GREENE PARK  
PARKING LOT, BASKETBALL AND TENNIS COURT REPLACEMENT  
Site # 614,  
4235 South Lipton Avenue  
St. Francis, WI.

Project Number: O060-11610, P129-11608, & P129-11609

Date of Addendum: September 29, 2011

### SHEET C-7:

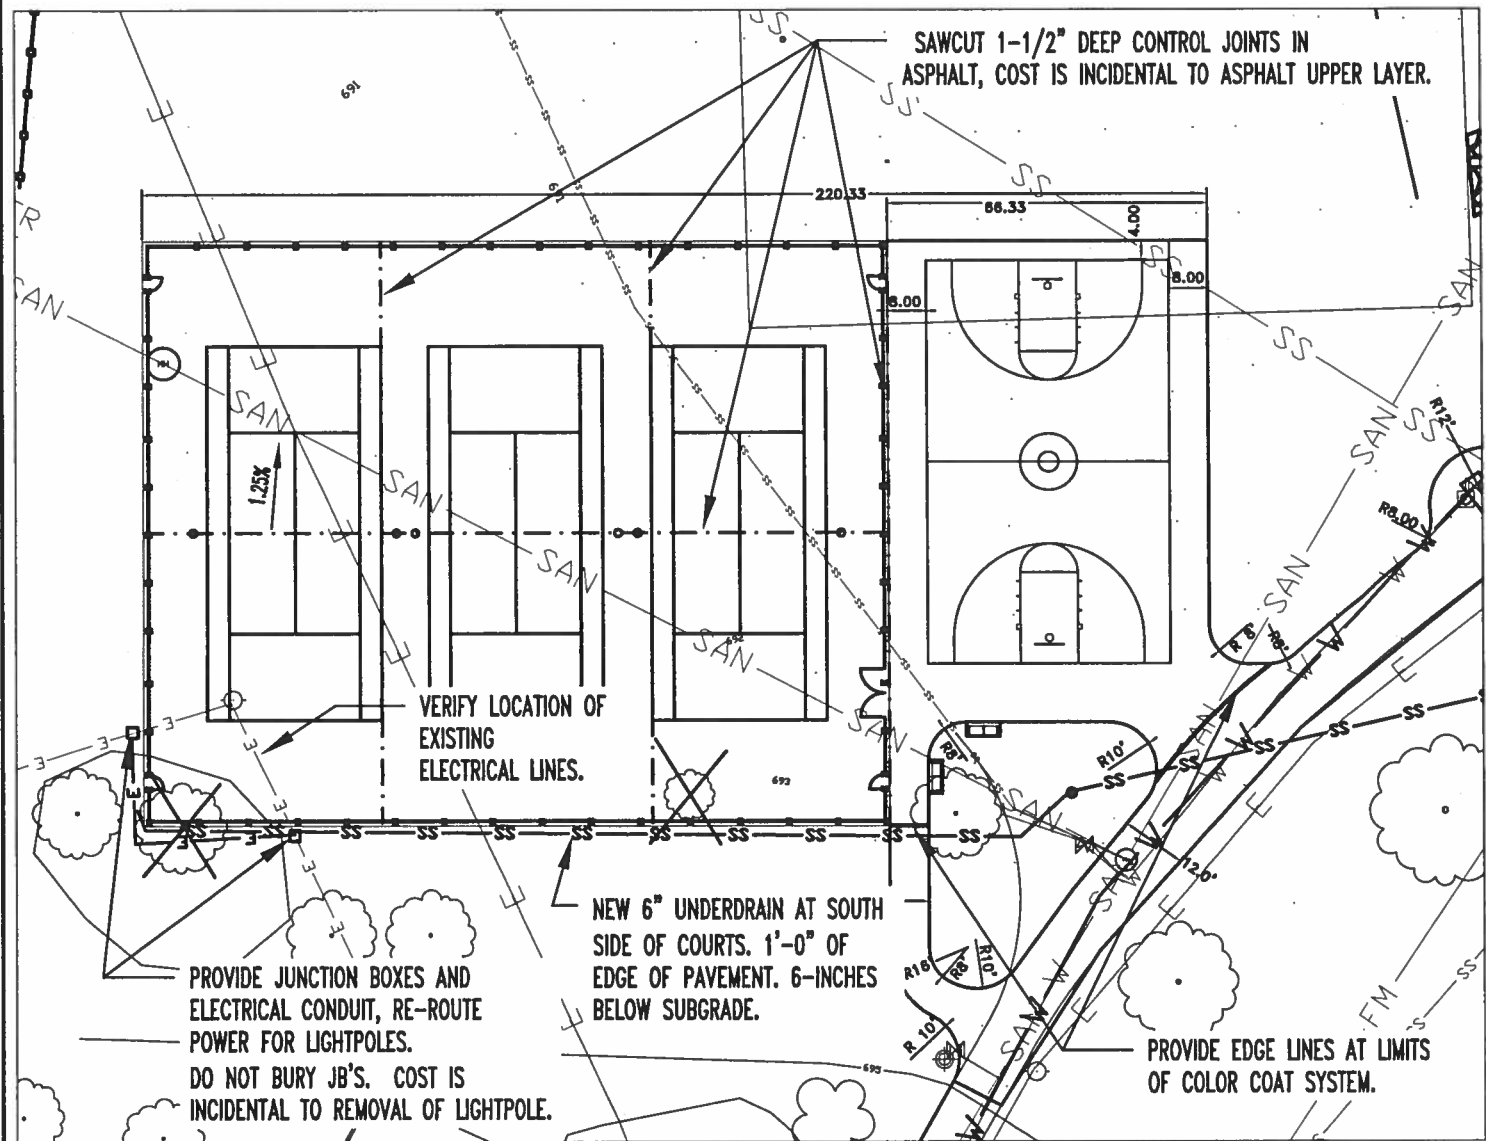
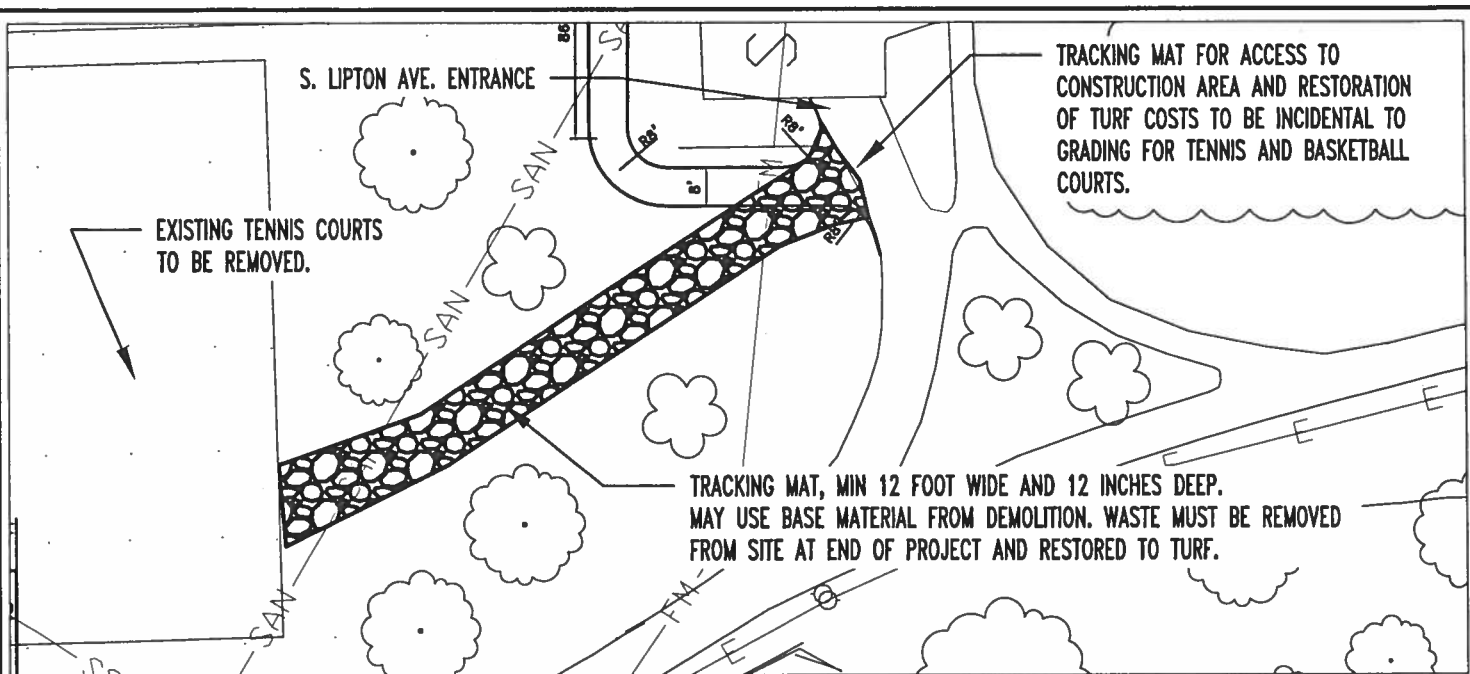
Three Tennis Court Layout Detail: Change dimension from edge of tennis court to fence line from 12.0' to 10.0' . Change dimension between courts from 10.0' to 12.0'

Remove Note: "1/4" x 5" STEEL ROADWAY CURB", No curb needed.
